**2 LDA2021/0123
 14 Ryedale Road, Denistone (proposed Lot 14A)**

Construction of part 1 and 2 storey boarding house with 8 boarding rooms for 16 lodgers and 4 parking spaces.

City of Ryde Local Planning Panel Report

DA Number	LDA2021/0123
Site Address & Ward	14 Ryedale Road, Denistone (proposed Lot 14A) West Ward
Zoning	R2 Low Density Residential
Proposal	Construction of part 1 and 2 storey boarding house with 8 boarding rooms for 16 lodgers and 4 parking spaces
Property Owner	KaritoINETTE Property Group
Applicant	Monument Design Partnership
Report Author	Kerry Gordon – Consultant Town Planner
Lodgement Date	20 April 2021
No. of Submission	81 plus petition with 290 signatures
Cost of Works	\$1,066,960
Reason for Referral to Local Planning Panel	More than 10 individual submissions
Recommendation	Refusal

Figure 8: Proposed Site Plan (excluding access handle)

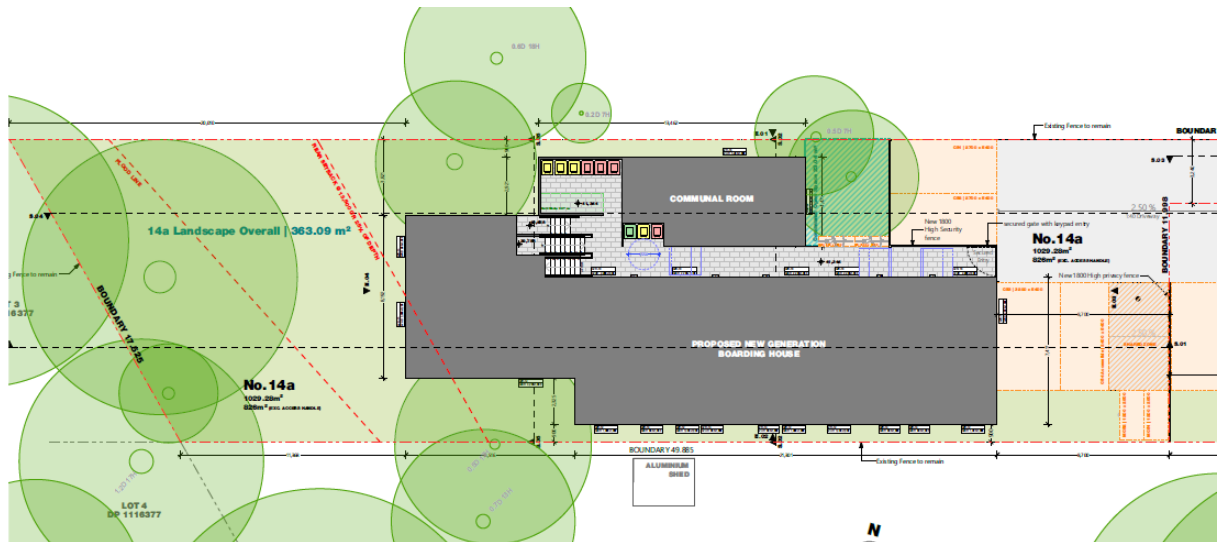
The plans do not indicate the provision of any fencing to the side or rear boundaries of the site but show a 1.8m high security fence between the parking area and smaller open space.

Figure 11: Proposed East and West Elevations

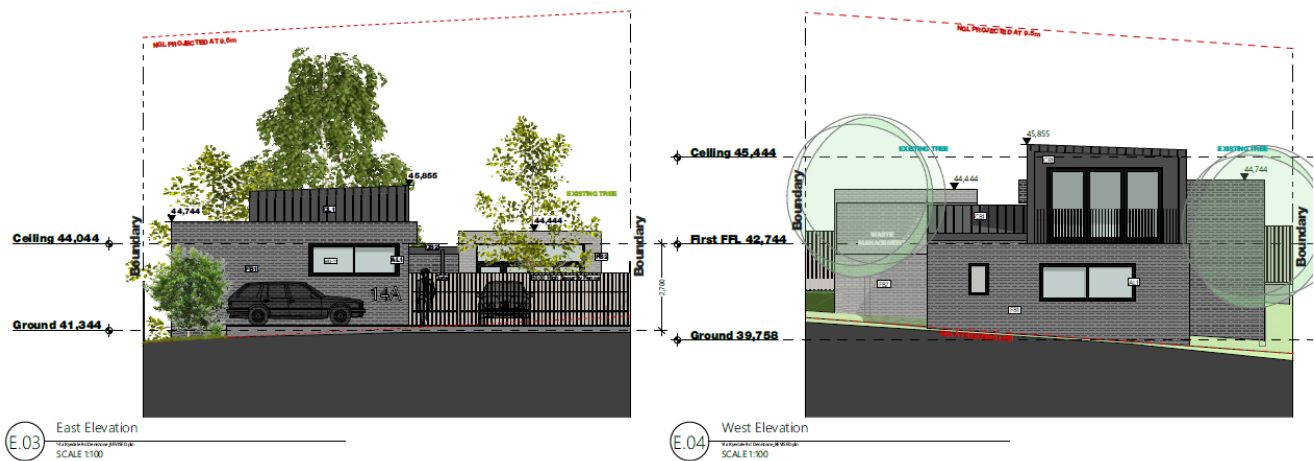
- Unacceptable landscaped setting.
- Design is uncharacteristic of the area in relation to flat roof, high security gate, length of building, colours and materials.

The design of the building is modern, with a flat roof and is to be constructed of a combination of pale brown and black face bricks and black metal cladding.
